Memorandum to the City of Markham Committee of Adjustment

File: A/38/19
Address: 112 Highland Park Blvd Thornhill
Applicant: MAX LUX INC (AMIR ADLI)
Agent: (none)
Hearing Date: Wednesday May 29, 2019

The following comments are provided on behalf of the West Team:

Project:	RESIDENTIAL 11 HIGHLAND PARK BOULEVARD, THORNHILL, ONTARIO
Scale:	1/4" = 1'
Sheet:	ARCHIT (11'x21')
Title:	SITE PLAN
Drawing No.:	A0.1

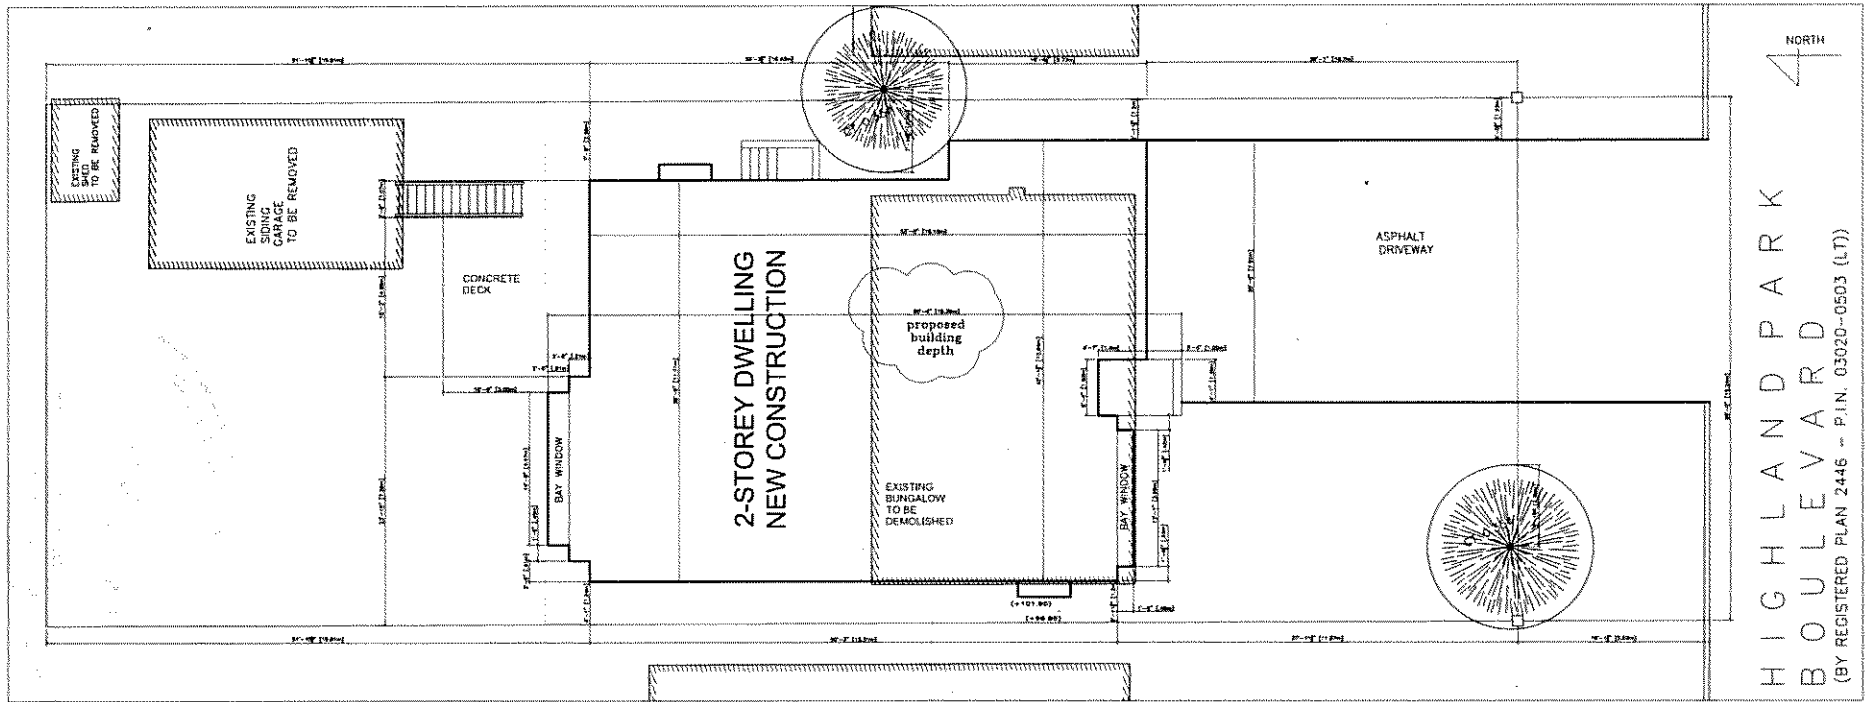
The applicant is requesting relief to permit a floor area ratio of 54.2 percent, whereas the By-law permits a maximum floor area ratio of 50 percent. The variance will facilitate the construction of a two-storey detached dwelling with a floor area of 333.89 m² (3,594 ft²), whereas the By-law permits a dwelling with a maximum floor area of 307.8 m² (3,313 ft²). This represents an increase of approximately 26.10 m² (281.48 ft²) or, approximately 8.5 percent. Staff are of the opinion that the proposed increase in FAR will not result in adverse impacts to abutting property owners.

The applicant is requesting relief to permit a maximum building depth of 18.39 m (60.33 ft), whereas the By-law permits a maximum building depth of 16.8 m (55.12 ft). This represents an increase of approximately 1.59 m (5.22 ft) or, approximately 9.5 percent.

Building depth is measured based on the shortest distance between two lines, both parallel to the front lot line, one passing through the point on the dwelling which is the nearest and the other through the point on the dwelling which is the farthest from the front lot line. The variance includes a front covered porch and rear projection (bay window) which add approximately 1.02 m (3.35 ft) and 1.22 m (4 ft) respectively to the overall depth of the building. The main component of the building, excluding the porch, has a depth of 16.66 m (54.66 ft) which complies with the by-law requirement. Given that the porch is unenclosed and well setback from the permitted side yards and, that the rear bay window does not occupy the full length of the rear wall, Staff are of the opinion that the requested variance is appropriate for the development and meets the intent of the infill by-law.

The applicant is requesting a minimum west side yard setback of 4 ft (1.2 m) for the two-storey portion of the dwelling, whereas the by-law requires a minimum side yard setback of 6 ft (1.8 m) the two-storey portion of the dwelling. This represents a difference of approximately 2 ft (0.61 m).

The requested variance only applies to the two-storey portion of the building. The main floor complies with the minimum side yard setback requirement. Engineering staff have reviewed the application and have no concern with the variance respecting drainage.

The applicant is requesting an unenclosed/unexcavated porch & eave front yard encroachment of 56 in (0.46 m) into a required yard, whereas the By-law permits a maximum unenclosed/unexcavated porch & eave front yard encroachment of 18 in (1.5 m). This represents an increase of approximately 38 inches. Staff are of the opinion that the requested variance is minor in nature.

1. That the front covered porch remain unenclosed;
2. The variances apply only to the proposed development as long as it remains;
3. That the variances apply only to the subject development, in substantial conformity with the plan(s) attached as 'Appendix B1' to this Staff Report and received by the City of Markham on *May 10th, 2019*, and that the Secretary-Treasurer receive written confirmation from the Director of Planning and Urban Design or designate that this condition has been fulfilled to his or her satisfaction;
